TECHNICAL SERVICE BULLETIN
Gear Shift Module (GSM) Concerns

26-2249
02 June 2026

Ford 2021-2025 F-150	Built on or before 8-Sep-2025
-------------------------	-------------------------------

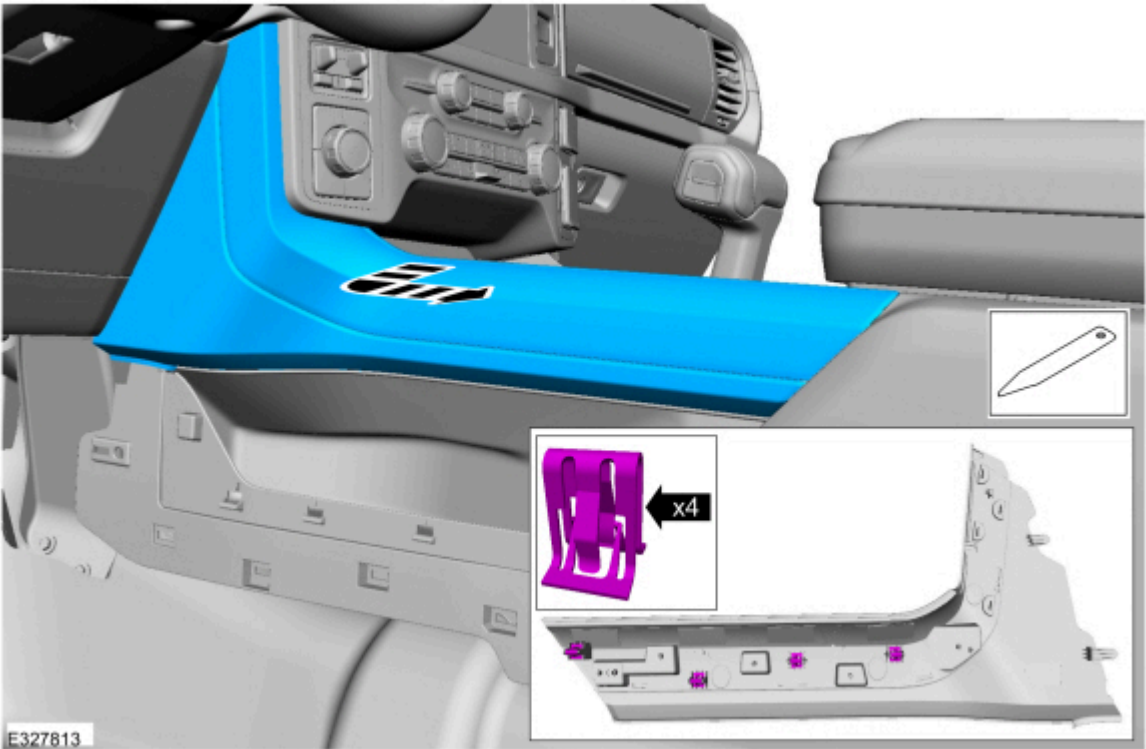
- With the system in Ready to Drive mode/engine running, apply and release the brake pedal while observing BRK_PDL_SW2 PID in the BCM. Does the BRK_PDL_SW2 PID change status when the brake pedal is pressed and released?
 - Yes - proceed to Step 2.
 - No - diagnose the brake pedal switch output and repair outside of this article. Refer to WSM, Section 307-05.
 - Is the vehicle built on or before 08-Sep-2025?
 - Yes - proceed to Step 3.
 - No - this article does not apply. Refer to WSM, Section 307-05.
 - Remove the left console trim to inspect the GSM build date. Refer to WSM, Section 501-12. (Figure 1)
- Figure 1

4. Verify the build date by using printed Julian date on the GSM. Refer to Table 1 and related bullet points.

5. Is the GSM built on or before 28-Aug-2025?

- (1). Yes - proceed to Step 6.
- (2). No - this article does not apply. Refer to WSM, Section 307-05 for normal diagnostics.

6. Replace the GSM. Refer to WSM, Section 307-05, which includes performing the PMI procedure to install the latest strategy files and carry out the TRON Module Authentication Procedure for 2024-2025 vehicles using the FDRS.
